FORD:

2013-2015 Explorer, Flex, Taurus

LINCOLN:

2013-2015 MKS, MKT

Figure 1 - Article 17-0063

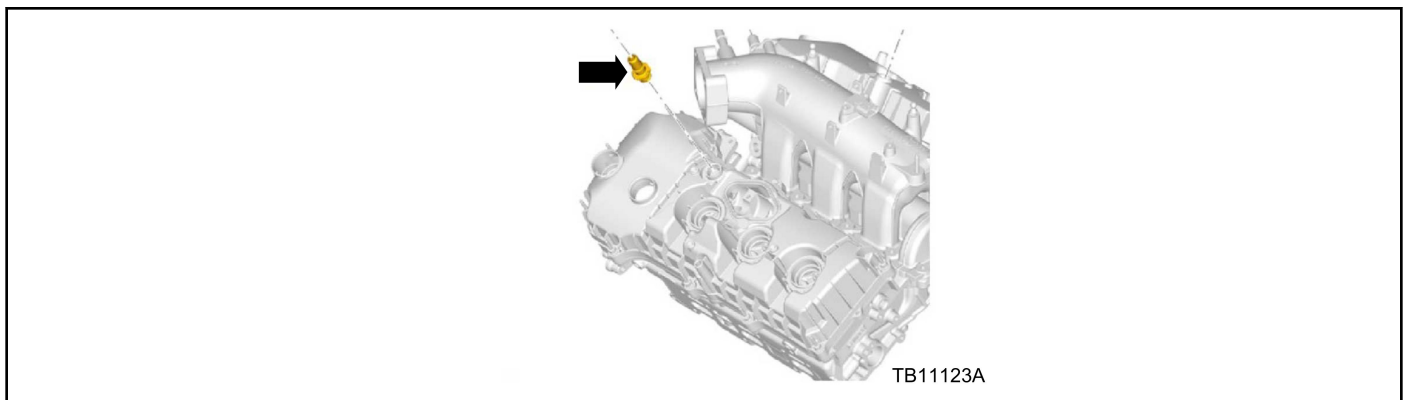
1. Remove the engine appearance cover, if equipped. Refer to Workshop Manual (WSM) Section, 303-08.
2. Inspect the color of the positive crankcase ventilation (PCV) hose to valve cover adapter. Is the adapter black in color? (Figure 1)

- a. Yes - proceed to Step 3.
 - b. No - this article does not apply. Refer to the Powertrain Control/Emissions Diagnosis (PC/ED) manual for diagnosis.
3. Disconnect the PCV hose to valve cover adapter quick connect fitting from the valve cover adapter. Refer to WSM Section 310-00.
 - a. When the valve cover adapter is removed, damage will occur to the valve cover adapter locking mechanism. Make sure detached pieces of the valve cover locking mechanism do not fall into the open valve cover port during removal. Rotate the adapter counterclockwise and remove from valve cover.
 4. Lubricate the new valve cover adapter O-ring seal with clean engine oil.
 5. Install the new green valve cover adapter.
 6. Connect the PCV hose to the valve cover adapter.
 7. Install the engine appearance cover if equipped. Refer to WSM, 303-08.
